CITY OF KIRKLAND
Planning and Building Department
123 Fifth Avenue, Kirkland, WA 98033
425.587.3600 ~ www.kirklandwa.gov

To: Design Review Board
From: Jennifer Anderer, Associate Planner
Date: November 7, 2022
File No.: DRV22-00569
Subject: **POLARIS AT TOTEM LAKE PROJECT
DESIGN RESPONSE CONFERENCE**

POLARIS AT TOTEM LAKE | 12335 120TH AVENUE NE, KIRKLAND, WASHINGTON 98034
DESIGN RESPONSE CONFERENCE - ROUND 2
11.07.2022

VERTICAL & HORIZONTAL MODULATION

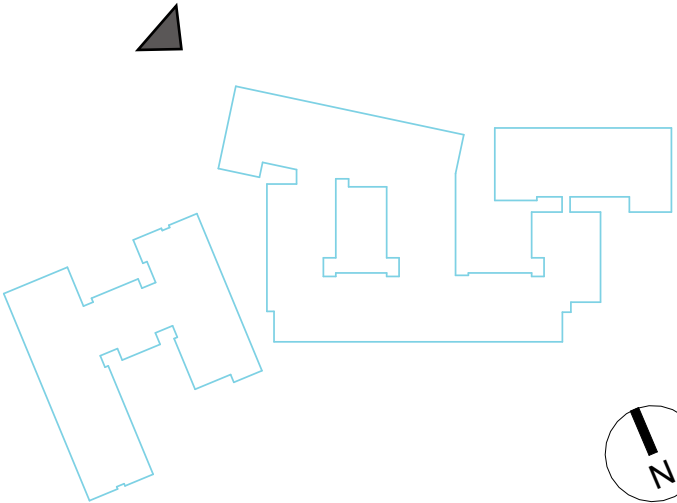
- 1.) Increase overall modulation and articulation particularly along 120th Ave NE

- (A) Material articulation
 - Texture variation - changes in fiber cement patterns from smooth to coarse help to add movement in the building facade which can be visible at various directions and times of the day
- (B) Additional modulation at levels 5 and 6 on Tower A - East Wing
- (C) Roof line parapet modulation - See page 7 for more information
- (D) Similar 2/3 Proportional relationship as Tower A - West Wing to create bookend appearance
- (E) Additional fenestration type/style to help further breakdown the scale of the facade and highlight more activated spaces within the building - See page 8 for more information
- (F) Vertical modulation to help break the corner anchor element from the rest of the primary building mass and emphasize verticality along the facade

VERTICAL & HORIZONTAL MODULATION

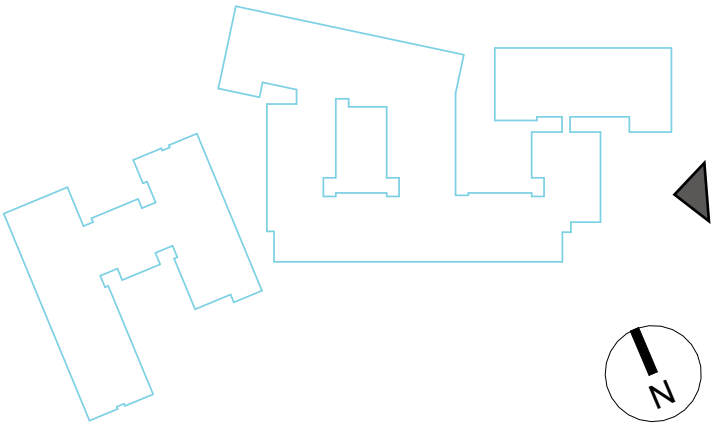
- 1.) Increase overall modulation and articulation particularly along 120th Ave NE

- (A) Material articulation
 - Texture variation - changes in fiber cement patterns from smooth to coarse help to add movement in the building facade which can be visible at various directions and times of the day
- (B) Additional modulation at levels 5 and 6 on Tower A - East Wing
- (D) Roof line parapet modulation - See page 7 for more information
- (E) Similar 2/3 Proportional relationship as Tower A - West Wing to create bookend appearance
- (F) Additional fenestration type/style to help further breakdown the scale of the facade and highlight more activated spaces within the building - See page 8 for more information
- (G) Vertical modulation to help break the corner anchor element from the rest of the primary building mass and emphasize verticality along the facade

ROOF LINE PARAPET MODULATION

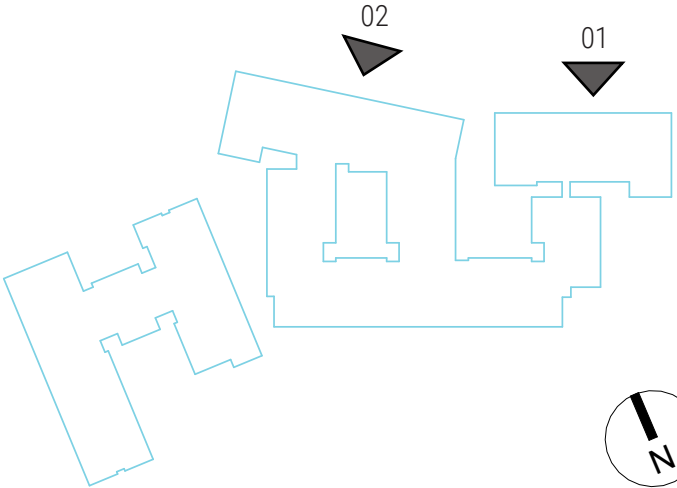
2.) More movement and breaking up of the parapet

We revised the exterior elevations to provide more modulation to the parapets at the roof. Vertical breaks at the roof now occur at each of the recessed wall locations. This move helps to break down the overall building mass into smaller, more vertical elements along the 120th Ave. NE frontage.

- (A) Increased parapet height by 2'-6" at corner anchor element
- (B) Increased parapet height by 1'-0"
- (C) Added vertical wall modulation
- (D) Omitted roof connection at recessed wall locations

FENESTRATION

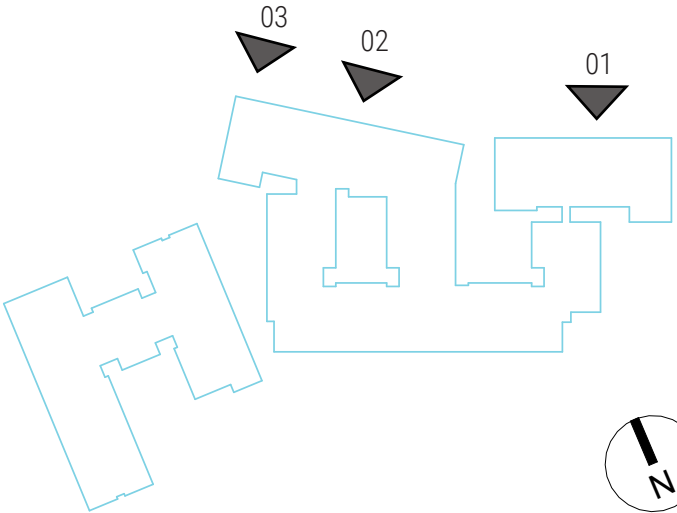
3.) Explore variation of window size and style

We have provided an additional window type/style to the project to help further breakdown the overall scale of the building as recommended by the board. By increasing the size of fenestration at certain unit living rooms along 120th Ave. NE. the overall floor to floor relationship is minimized and therefore reduces the vertical scale/precieved height of the building. Larger window openings at these living areas also help to breakdown the horizontal patterning, creating relief points in the building facade. In addition, the board made a comment in regards to the detailing of the scallop infill panels. The comment stated that they are a nice touch but might be more affective if pedestrians at the street level could witness the variation in their faceting. In response, we revised the single slope scallop to provide a folded scallop which still provides minimal surfacing for dirt and debris collection but allows for shape variation which can be seen from below.

- (A) Added window type / style
- (B) Two window types/ styles are grouped together to provide the appearance of a larger opening
- (C) Deep recessed windows
- (D) Folded scallop infill panels

CORNER ANCHOR

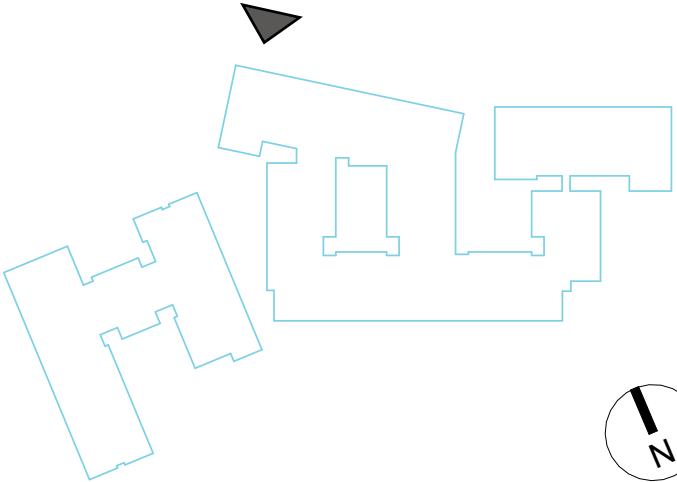
- 4.) Expand the corner towerer so it functions as an accent and anchor of the building

We have revised numerous aspects of the corner anchor element from our last DRC meeting on October 3rd. Based on the boards feedback there was just something intangible about this portion of the building that didn't corelate to the rest of project and furthermore lacked definition to further promote an "anchor element". The following points represent the revisions that have taken place:

- (A) We revised the column layout to better align with the perimeter of the corner anchor and help ground this element
- (B) Vertical modulation to help break the corner anchor element from the rest of the primary building mass and emphasize verticality along the facade
- (C) Raised the parapet to help emphasize the priority of this corner anchor element
- (D) Removed the parapet extension to isolate this element and once again promote vertically
- (E) We revised the fenestration on both facades to provide larger openings and therefore create a stronger more visually interesting aspect of the project

PEDESTRIAN-FRIENDLY BUILDING FRONTS

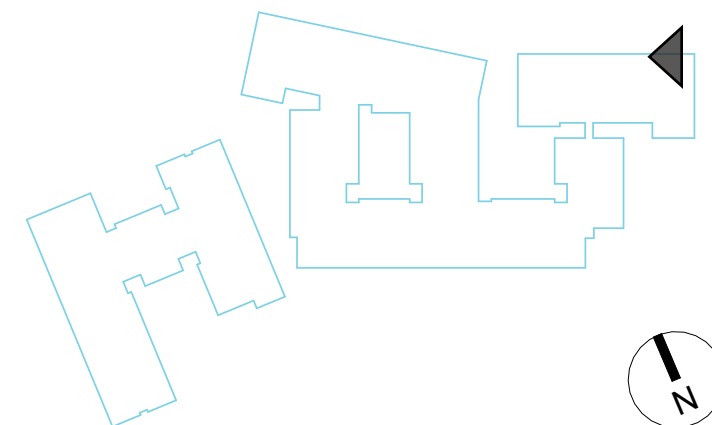
- 1.) Ground floor activation through use of benches, pavers, landscaping.
- 2.) Expand the amount of frontage along 124th Ave NE that engages the public.
- 3.) Explore artwork opportunities within enhanced landscaping spaces particularly in and around the parking garage.

- (A) By providing more seating nodes along the frontage we have created more opportunities of reprieve, interaction as well as reflection for patrons and the public alike
- (B) The intent is to provide a decorative paving pattern either through the use of linear concrete pavers in multiple gray tones or through saw cut concrete slab on grade
- (C) By reducing the square footage of certain raised planters we have revised the proposed open space layout to provide more area for pedestrian circulation and gathering
- (D) We have enhanced the pedestrian experience along 120th Ave. NE by taking the board's advice and incorporating a "butterfly garden" through the use of specific landscaping techniques
- (E) We have also provided decorative metal panels as a backdrop to the landscaping which doubles as screening for the proposed surface parking lot in this region of the project

PEDESTRIAN-FRIENDLY BUILDING FRONTS

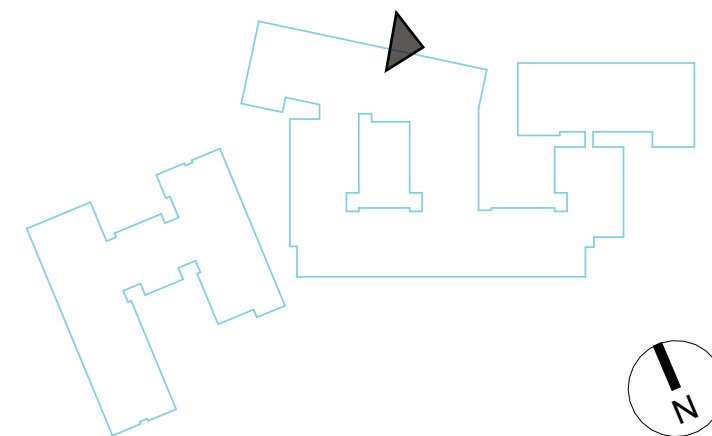
- 1.) Ground floor activation through use of benches, pavers, landscaping.
- 2.) Expand the amount of frontage along 120th Ave NE that engages the public.
- 3.) Explore artwork opportunities within enhanced landscaping spaces particularly in and around the parking garage.

- (A) By providing more seating nodes along the frontage we have created more opportunities of reprieve, interaction as well as reflection for patrons and the public alike
- (B) The intent is to provide a decorative paving pattern either through the use of linear concrete pavers in multiple gray tones or through saw cut concrete slab on grade
- (C) By reducing the square footage of certain raised planters we have revised the proposed open space layout to provide more area for pedestrian circulation and gathering
- (D) We have enhanced the pedestrian experience along 120th Ave. NE by taking the board's advice and incorporating a "butterfly garden" through the use of specific landscaping techniques
- (E) We have also provided decorative metal panels as a backdrop to the landscaping which doubles as screening for the proposed surface parking lot in this region of the project

PEDESTRIAN-FRIENDLY BUILDING FRONTS

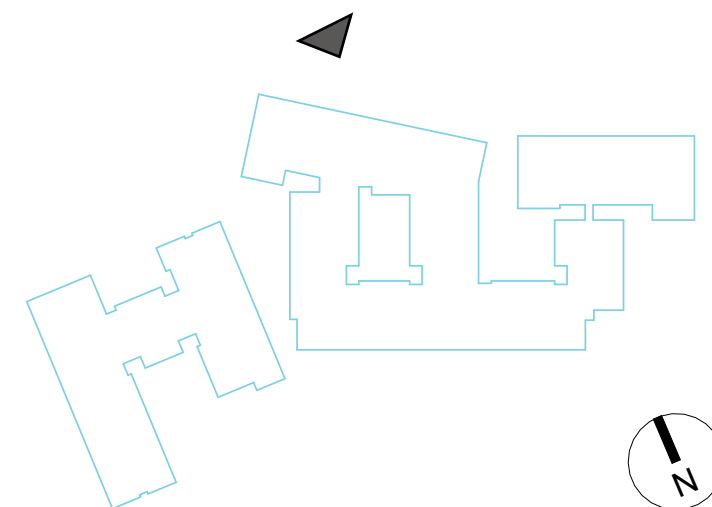
- 1.) Ground floor activation through use of benches, pavers, landscaping.
- 2.) Expand the amount of frontage along 124th Ave NE that engages the public.
- 3.) Explore artwork opportunities within enhanced landscaping spaces particularly in and around the parking garage.

- (A) By providing more seating nodes along the frontage we have created more opportunities of reprieve, interaction as well as reflection for patrons and the public alike
- (B) The intent is to provide a decorative paving pattern either through the use of linear concrete pavers in multiple gray tones or through saw cut concrete slab on grade
- (C) By reducing the square footage of certain raised planters we have revised the proposed open space layout to provide more area for pedestrian circulation and gathering
- (D) We have enhanced the pedestrian experience along 120th Ave. NE by taking the board's advice and incorporating a "butterfly garden" through the use of specific landscaping techniques
- (E) We have also provided decorative metal panels as a backdrop to the landscaping which doubles as screening for the proposed surface parking lot in this region of the project
